Compass Housing Alliance
Compass on Dexter Building

Design Review Board Recommendation

Project # 3012408

December 5, 2012

Conceptual Lighting Plan - Level 1

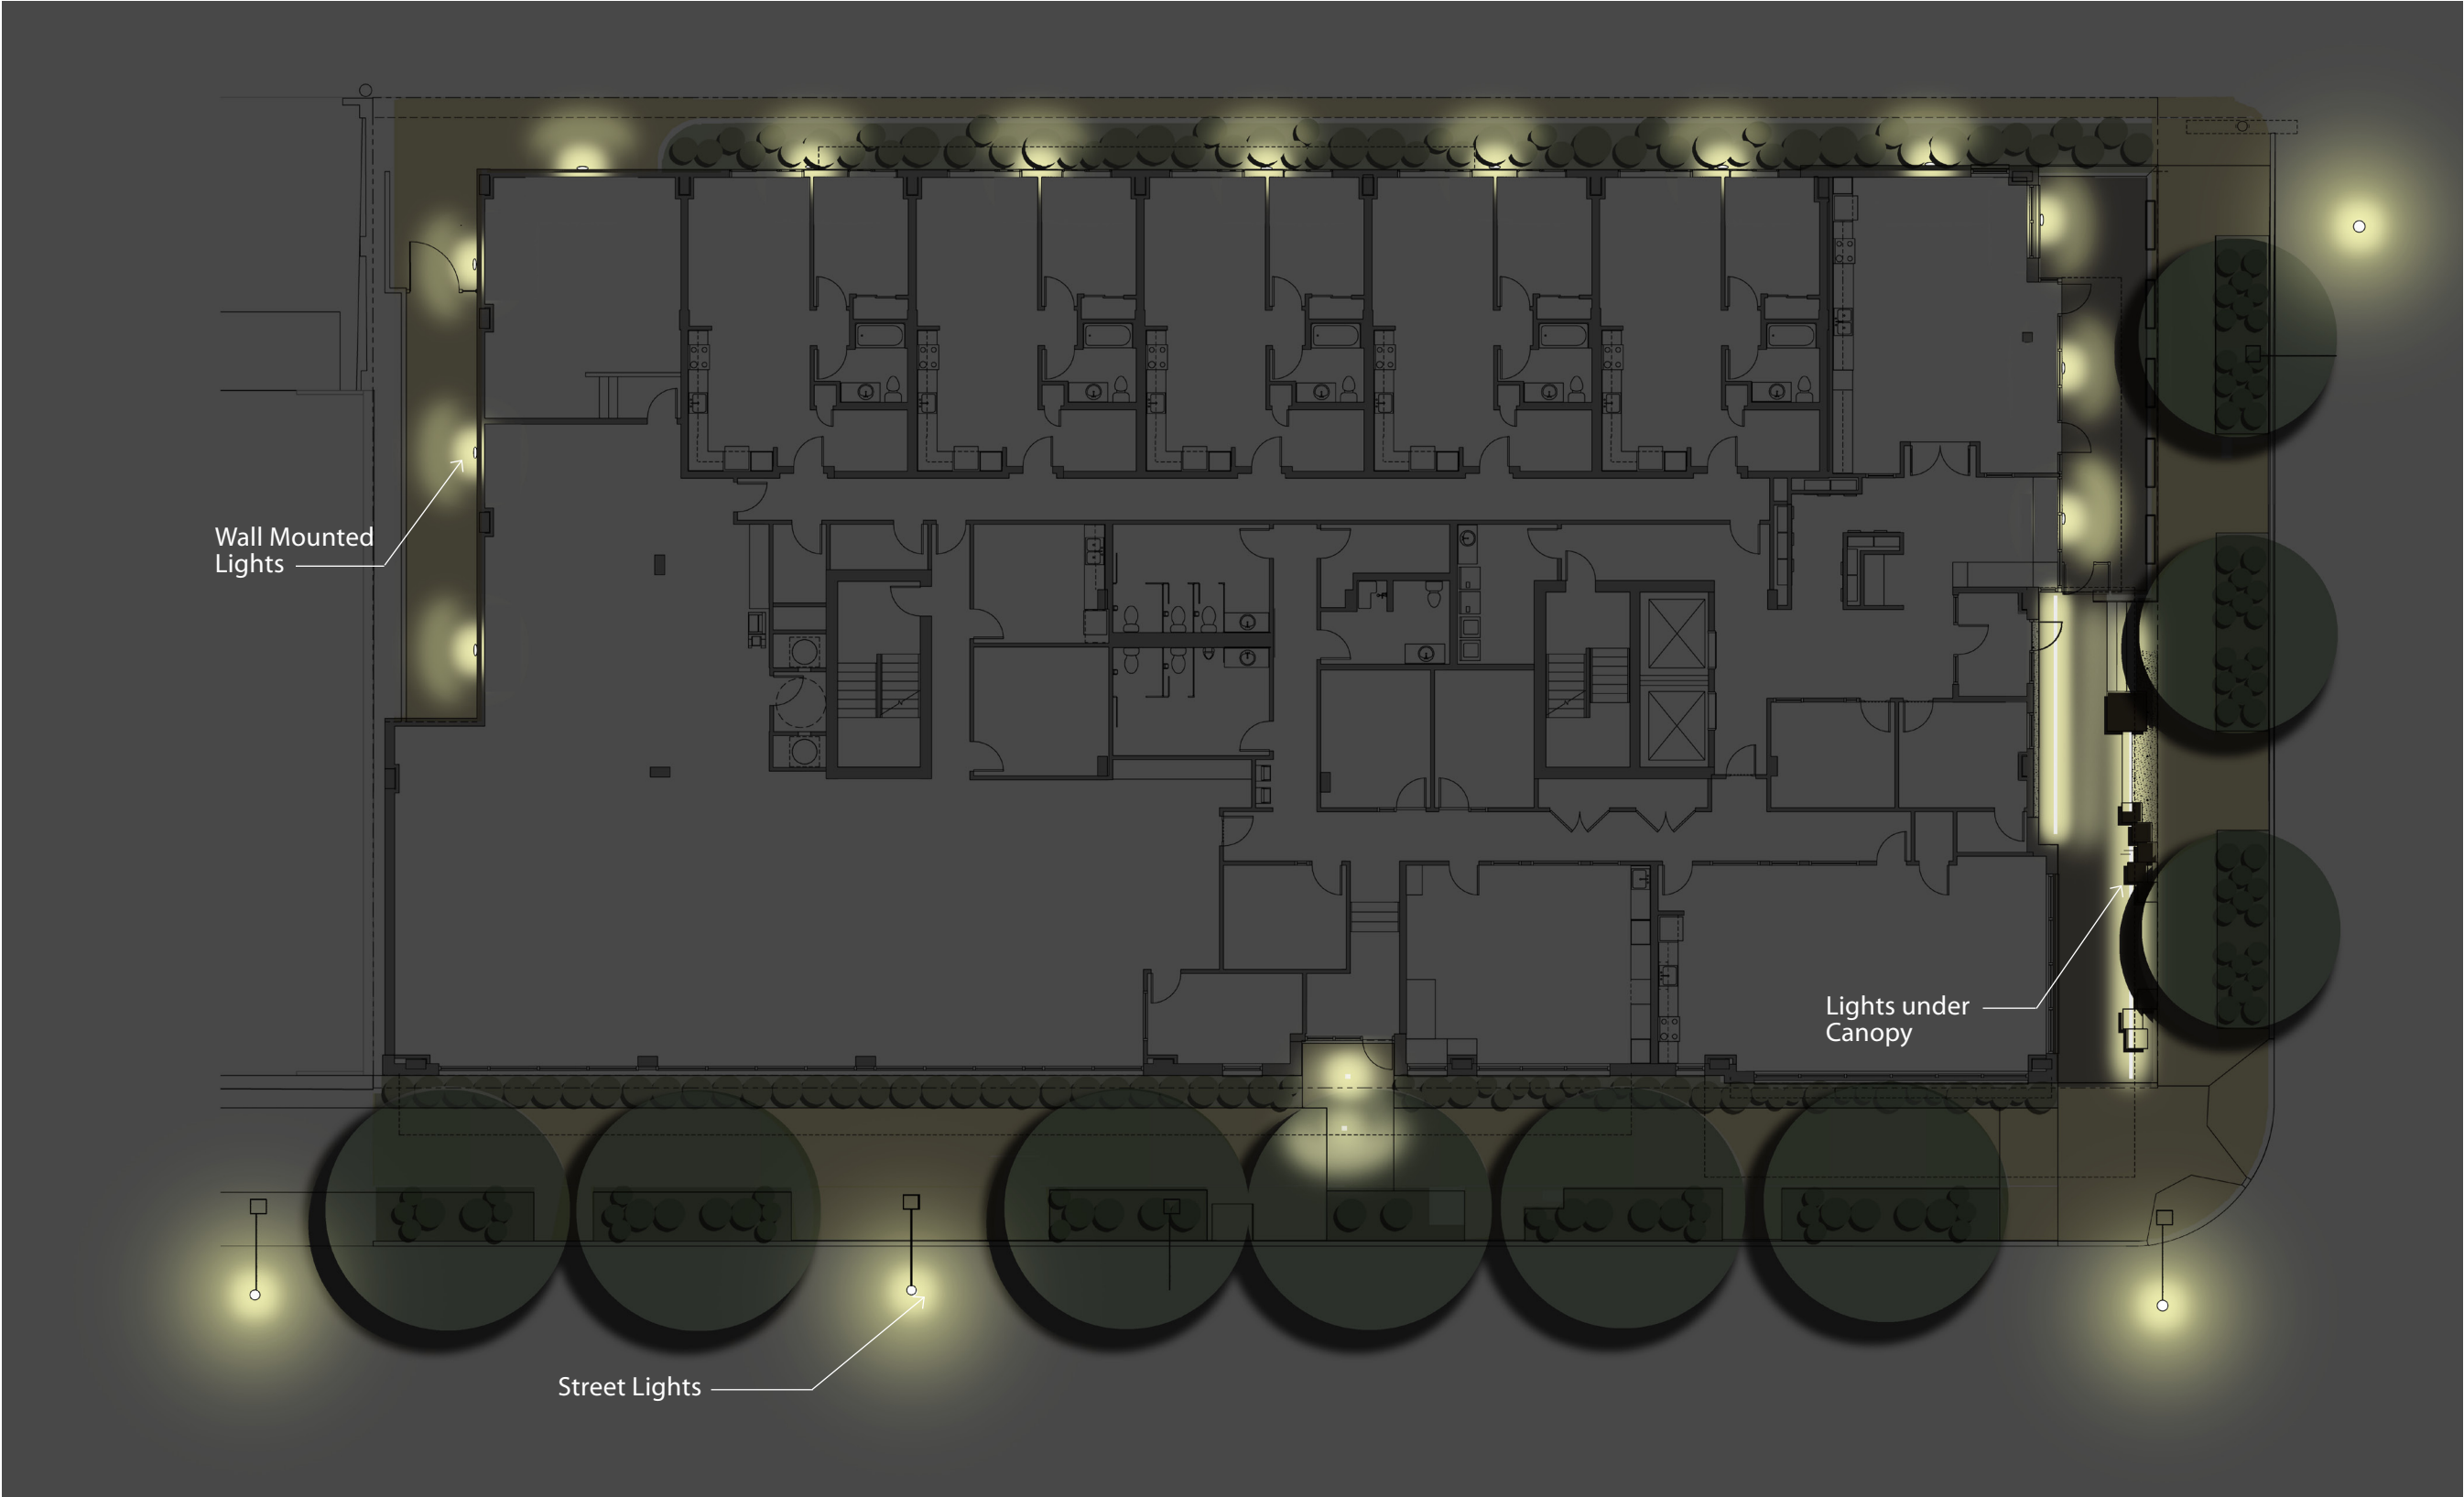
EDG Comment:

A concept lighting plan will be needed for the Recommendation meeting. Lighting along the alley will be of particular importance.

Response:

Lights will provide necessary light for visibility and security while avoiding light or glare spilling out onto street and irritating drivers or pedestrians, impacting residential windows or church across alley. Hours of lighting at resident outdoor spaces controlled by management.

Departure 3 - Dexter Ave Transparency

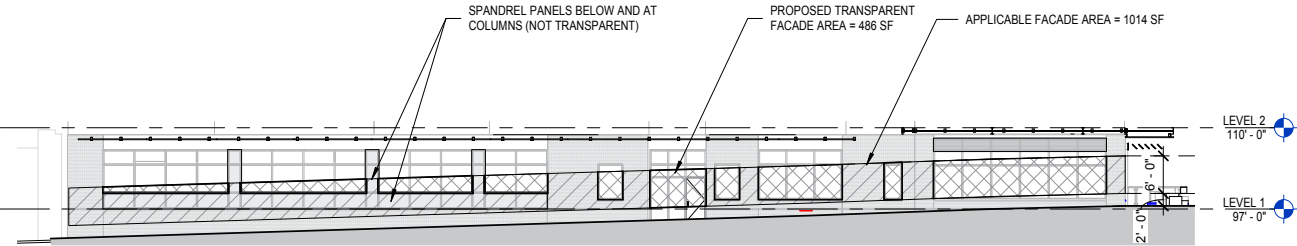
EDG Comment:

Due to the change in grade along Dexter Ave N., the Board requested diagrams illustrating how the proposal meets land use code transparency requirements.

Zoning Code Reference	Departure	Rationale
Departure 3: Transparency		
23.48.018 Transparency Requirements	Dexter Ave min. 45% transparency between 2 FT and 8 FT from street level.	Transparency provided for dexter Ave N elevation overall approximately 46% for area between two and eight feet above sidewalk.
Dexter Ave (Class 2 Pedestrian Street) min. 60% transparency between 2 FT and 8 FT from street level.		Character of Dexter Ave N more defined by status as an arterial street with high speeds and volumes of automobile and bicycle traffic than by pedestrians.
		Interconnectedness of building’s internal program uses and ADA accessibility standards require ground floor all to be on a single level, creating inherent hardship in meeting transparency standard at north end, where sidewalk elevation is the lowest.
		Mitigating measures: <ul style="list-style-type: none">• Significant transparency provided above zone of requirement.• Glass-faced spandrel panels in lower portion of storefront system.• Brick beneer extends down to ground at all street-facing facades.• Projecting precast concrete sill element below storefront windows.• Treatment of below-sill area with abstract patterning of multiple brick colors.• Foundation planting softens non-transparent edge where building wall meets sidewalk.
